**DATE:** February 7, 2011

**SUBJECT: Addendum No. 3**  
**Green Valley Road at Tennessee Creek Bridge Replacement Project**  
**(Contract No. PW 09-30407, CIP No. 77109)**

**GREEN VALLEY ROAD AT TENNESSEE CREEK**  
 BRIDGE REPLACEMENT PROJECT  
**6" WATERLINE - PLAN & PROFILE**

SHEET  
**W-2**  
 53 OF 61  
 W.O. No. 77109

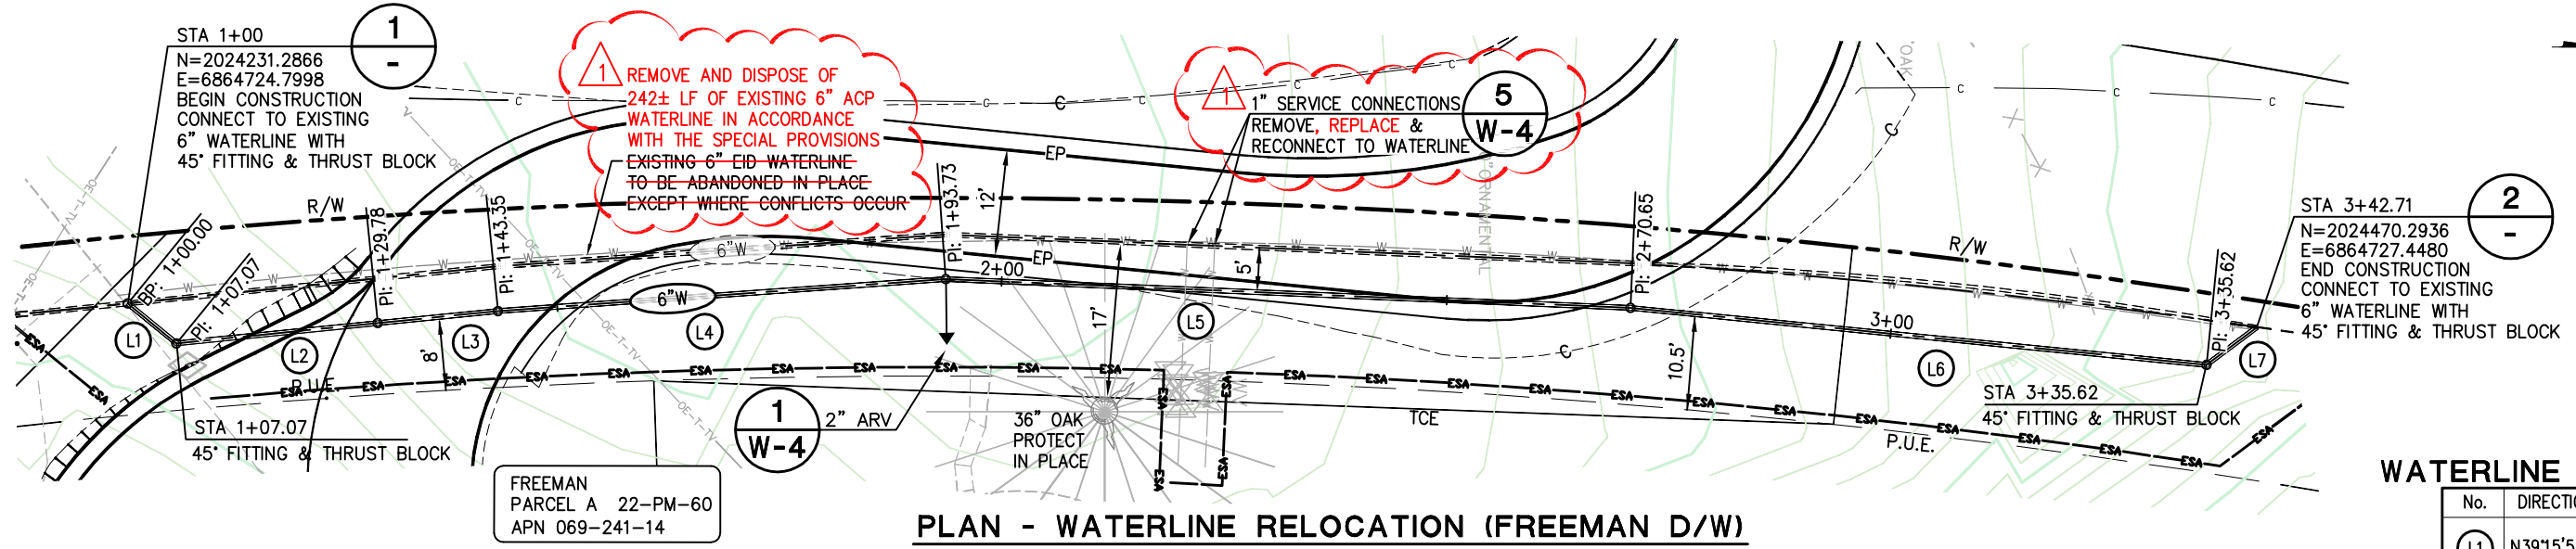
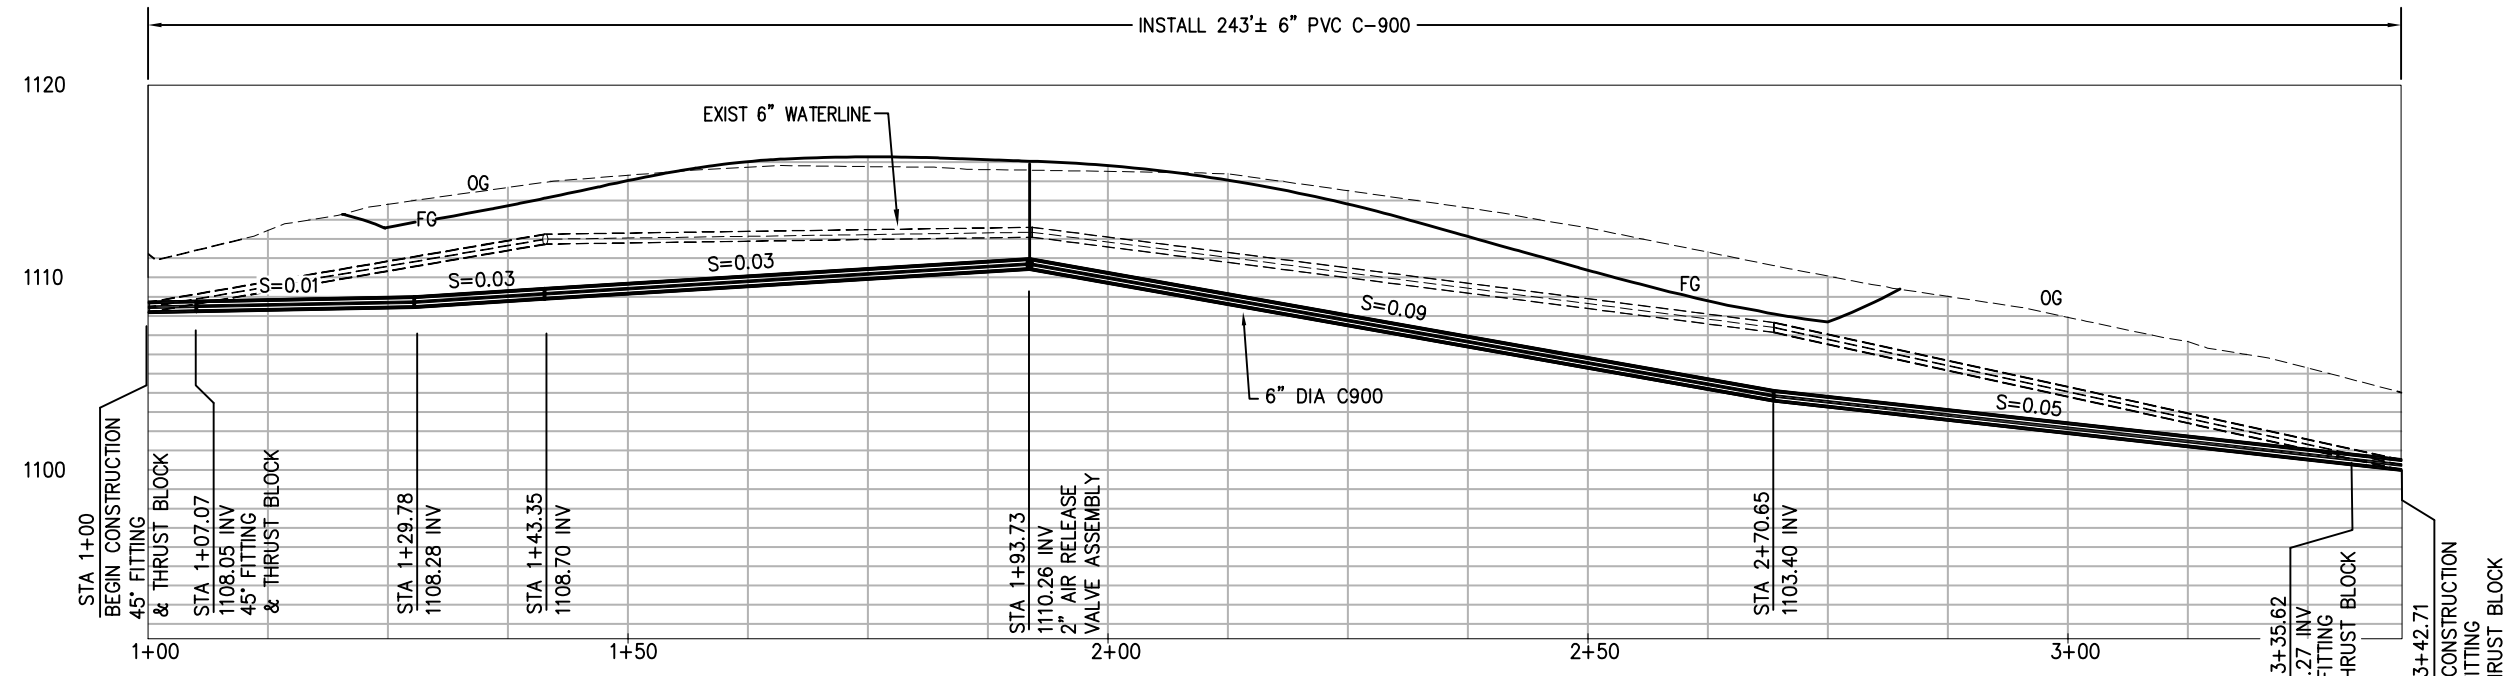
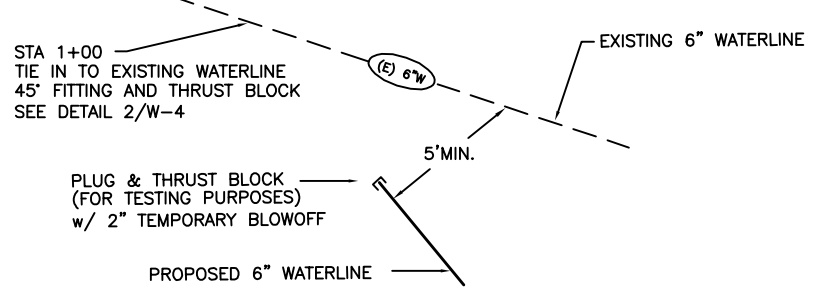
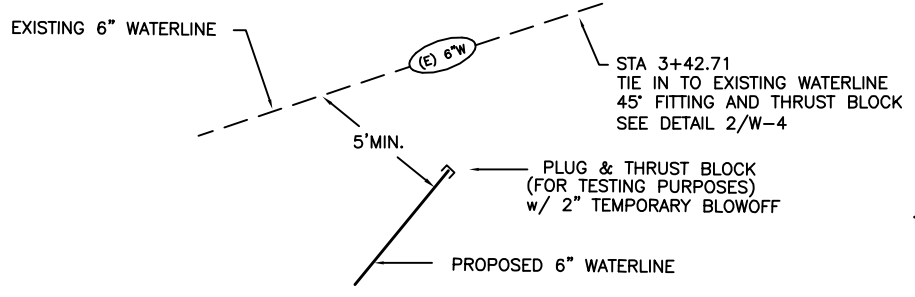
| ITEM NO. | LOCATION, PAGE OR DRAWING NO. | DESCRIPTION OF CHANGE   |
|----------|-------------------------------|---|
| 3.01     | Plan Sheets 53 and 54         | To address the bidder's question regarding the quantity of "asbestos containing material removal" and 1" service lines plans sheets W-2 (53 of 61) and W-3 (54 of 61) have been revised.<br><b>Bidders are instructed to replace original plan sheets 53 of 61 and 54 of 61 with the revised sheets 53 of 61 and 54 of 61 attached to this Addendum No. 3.</b>  |
